SALEM GENERATING STATION - UNIT NO. 1  
OVERPRESSURIZATION PROTECTION  
DOCKET NO. 50-272

ANSWERS TO THE QUESTIONS CONTAINED IN

ENCLOSURE NO. 1  
STAFF POSITION AND INFORMATION REQUESTS  
SALEM NUCLEAR GENERATING STATION - UNIT NO. 1  
DOCKET NO. 50-272

RCS PRESSURE - TEMPERATURE LIMITS

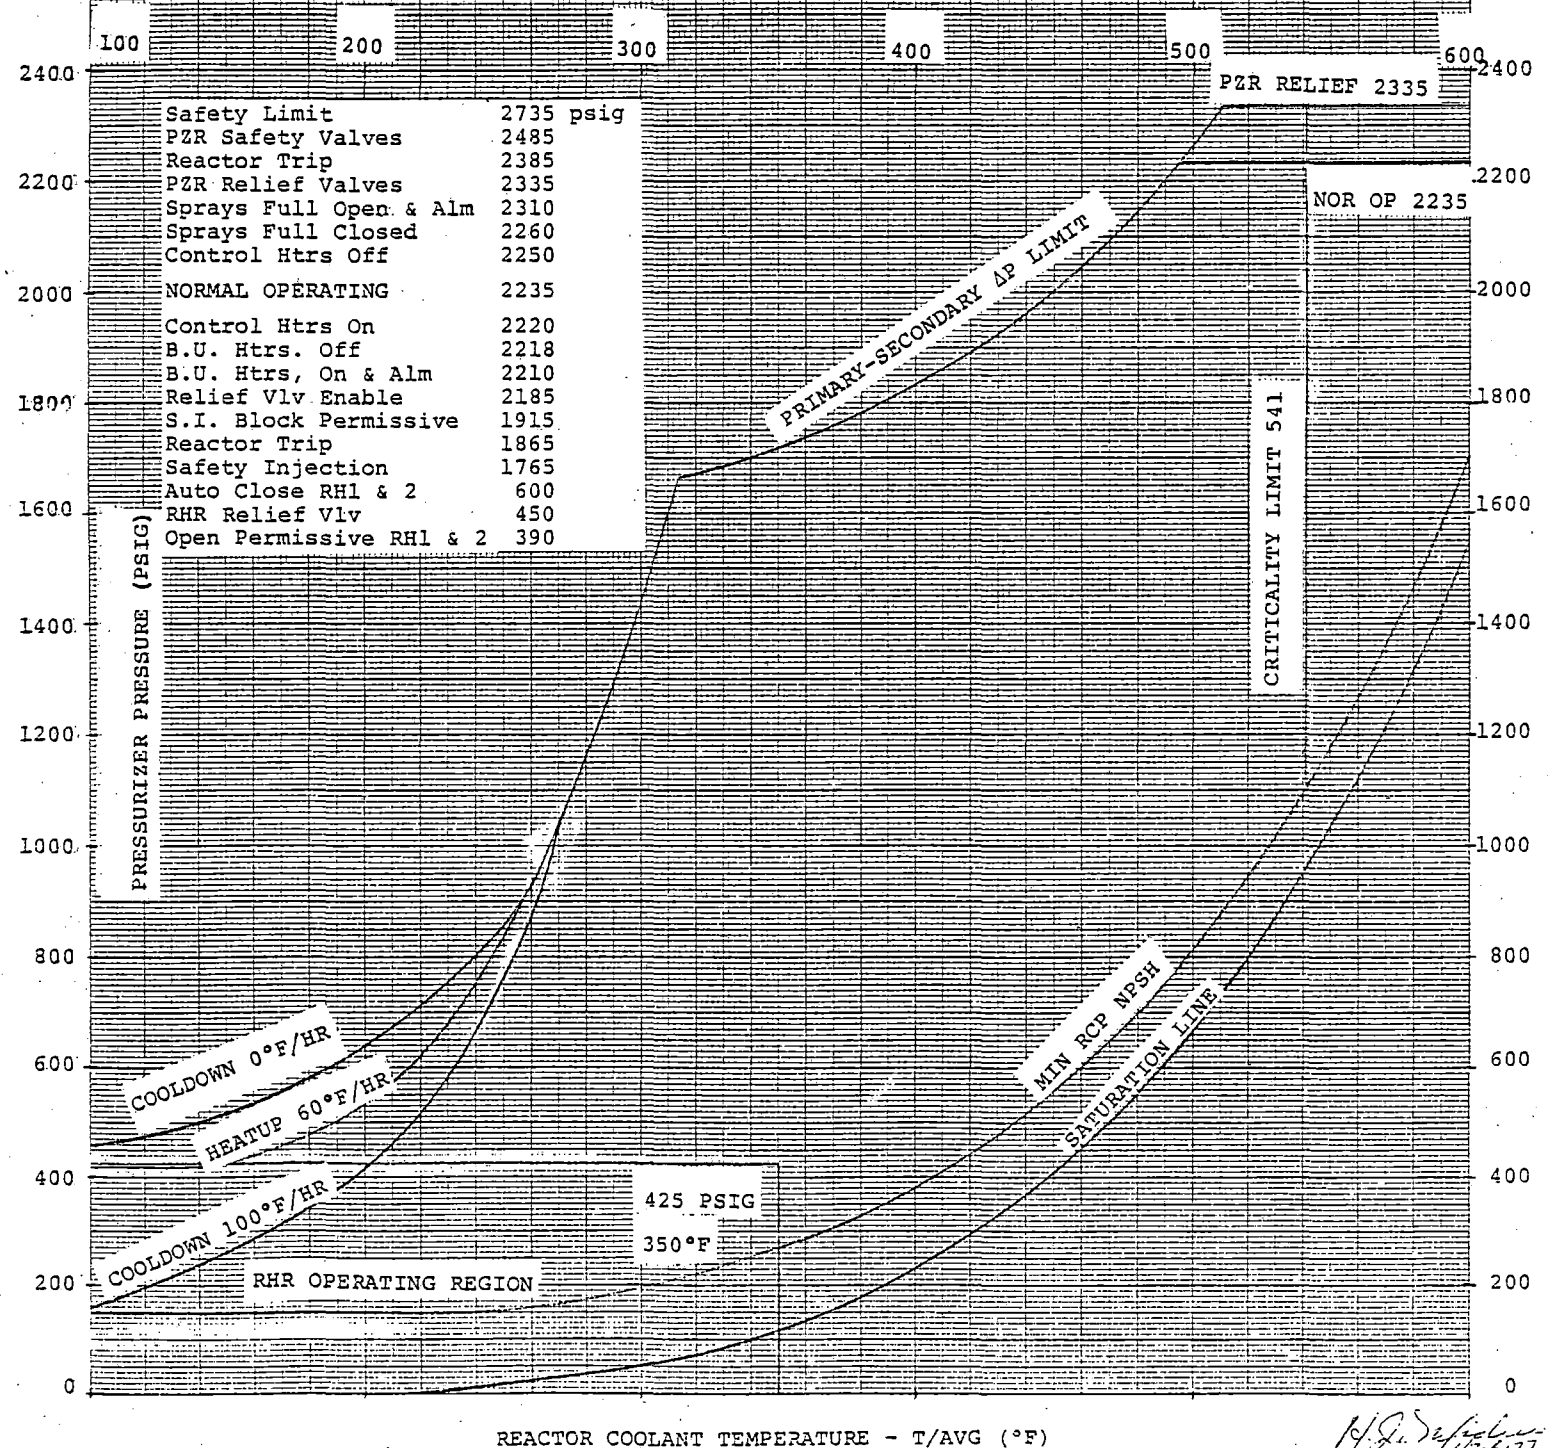
The equations for the pressure temperature limit for heatup rates up to 60°F/Hr curve (Fig. 3-4-2) in the Technical Specifications, was determined by a standard curve fit program used on a Univac Computer and was subsequently programmed into the Salem No. 2 Unit Prodac-250 Computer for checkout. Following the checkout the program was locked into the Salem No. 1 Unit Prodac-250 Computer and is currently in service. The inputs are adequately isolated from all safety-related instrumentation to have no adverse effects on that instrumentation.

- e) The residual heat removal pump high discharge pressure alarm is set at 600 psi (+0-12 psi) and will alarm in the control room.
- 7a) The Appendix G pressure limit is 410 psi and the minimum pressure needed for RCP operation is a pressure sufficient to maintain a minimum of 285 PSID across No. 1 RCP seal. Enclosed is the operating curve for Salem No. 1.

No. 11 SI Pump

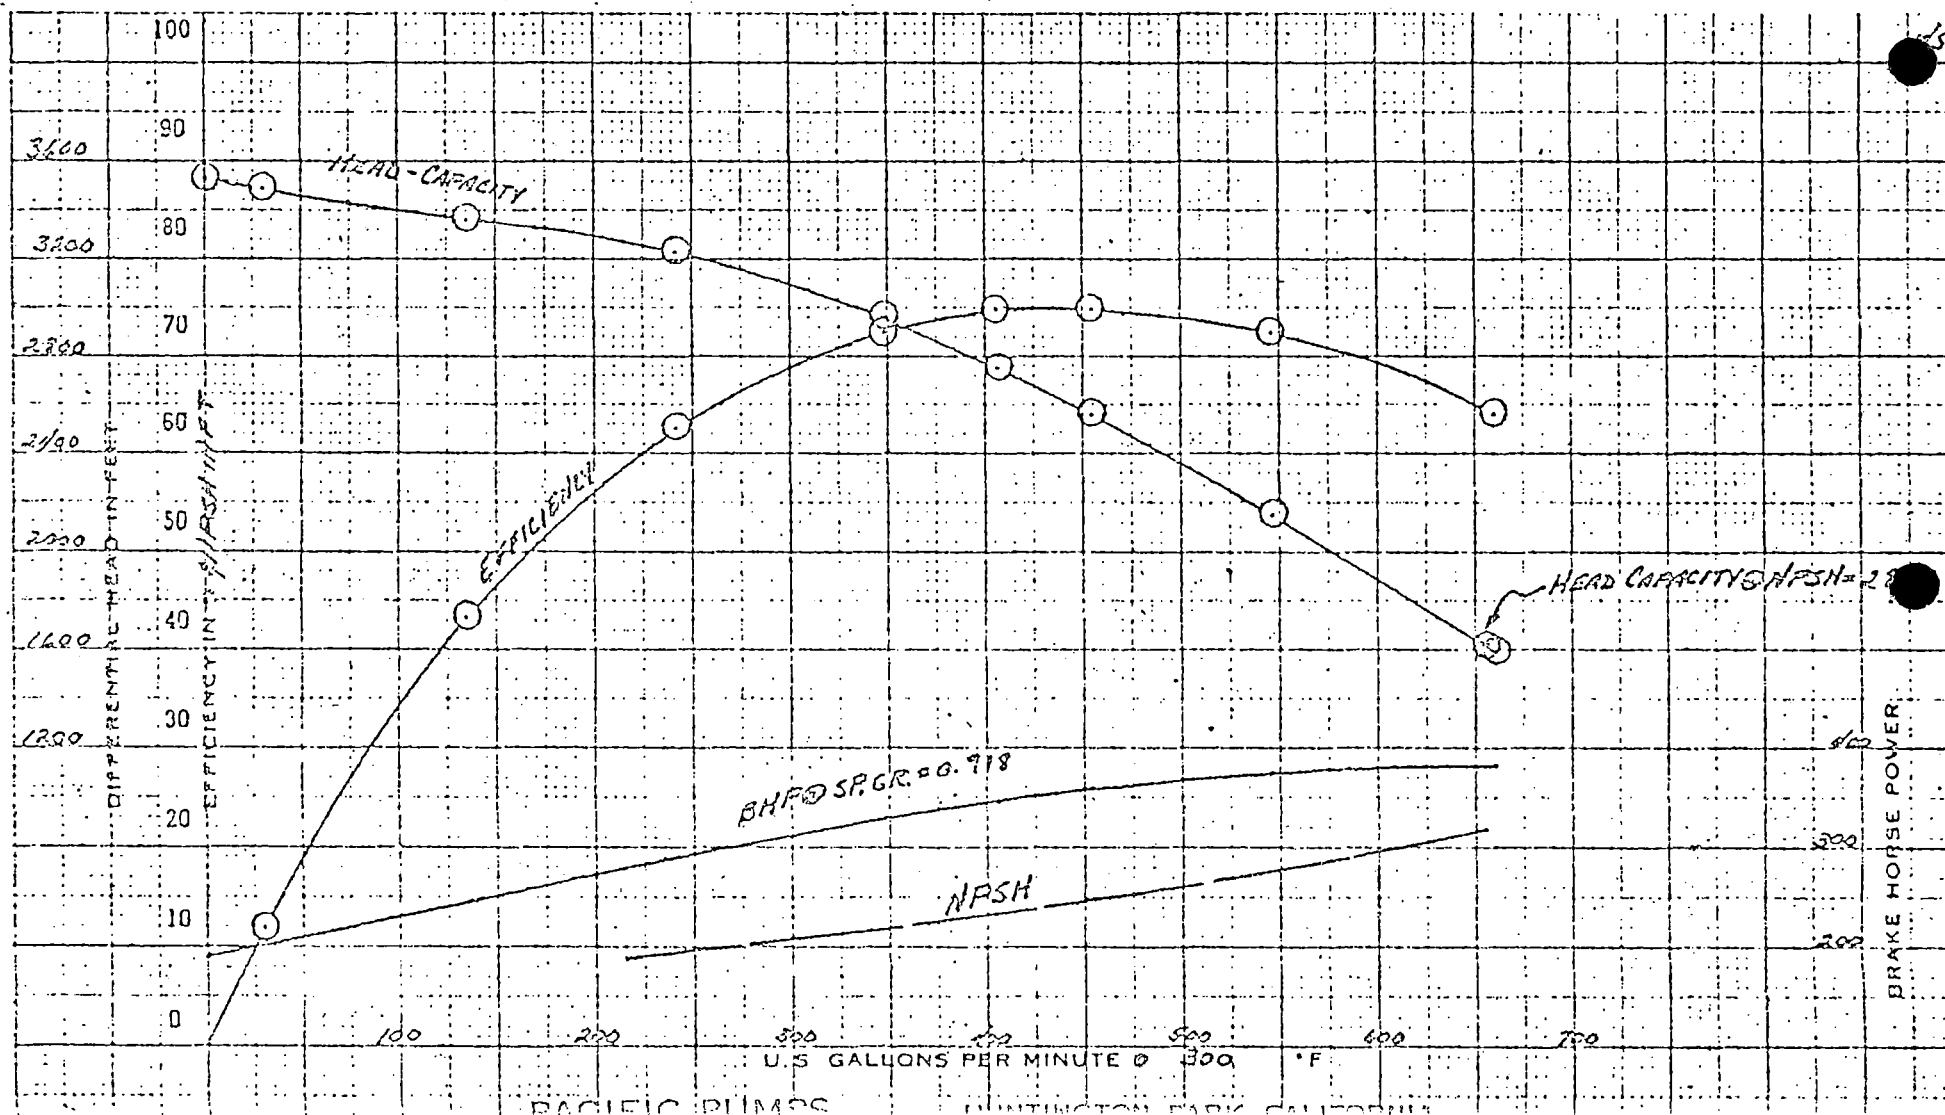
- b) The head-flow characteristics for each of the safety injection pumps are provided in Attachment #1.
- c) On-the-spot changes are to be made by March 28, 1977, to OI I-3.6, "Hot Standby to Cold Shutdown", and OI I-3.2, "Cold Shutdown to Hot Standby". These changes will deenergize the proper pump and valves during cold shutdown operation.
- d) The SIS pumps and valves may not be isolated and deenergized under the following circumstances:
  - 1) Valve stroking and pump operation following scheduled maintenance that is required for in-service testing of valves and pumps.
  - 2) Valve stroking and pump operation required by the Safety Technical Specifications valve and pump in-service testing program.
  - 3) An inoperative positive displacement pump requiring the operation of a centrifugal pump as required by the Technical Specifications.

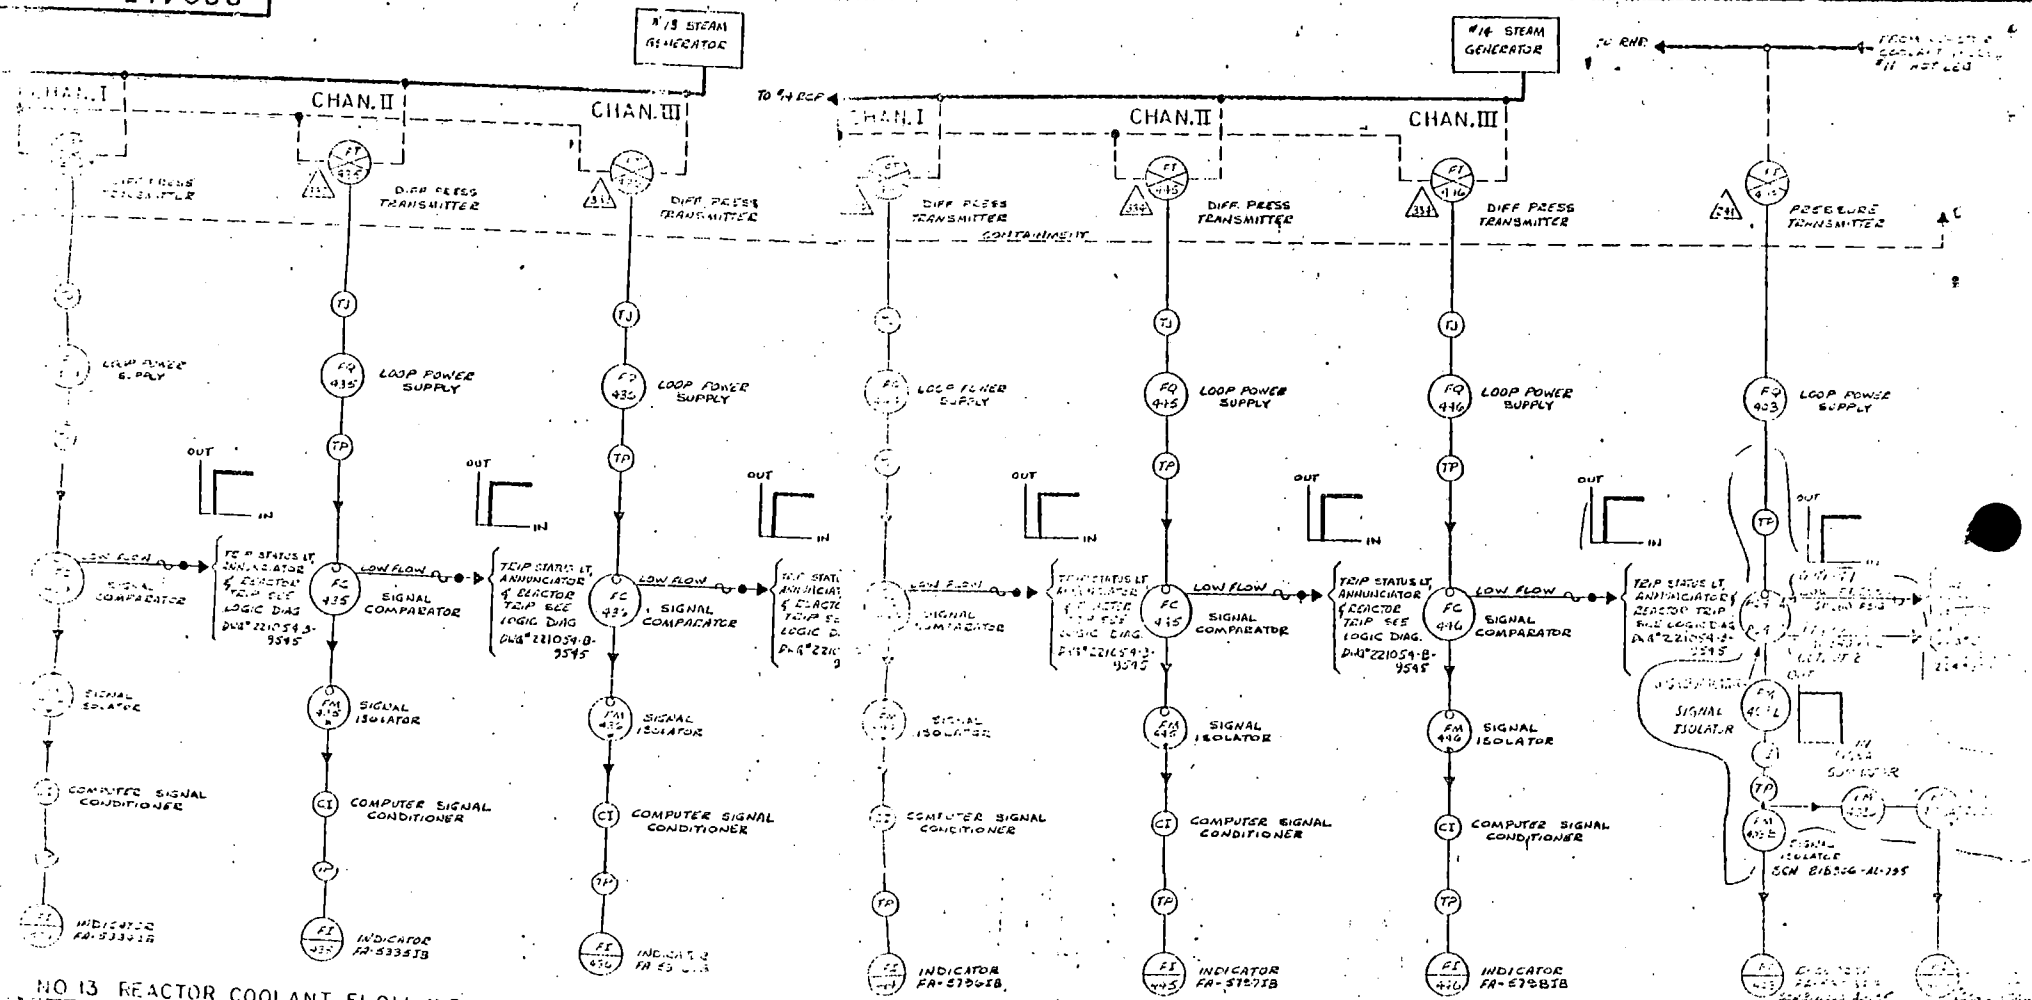
Enclosed are Diagram Nos. 220413 and 205201 which include the piping and instrument drawing requested.
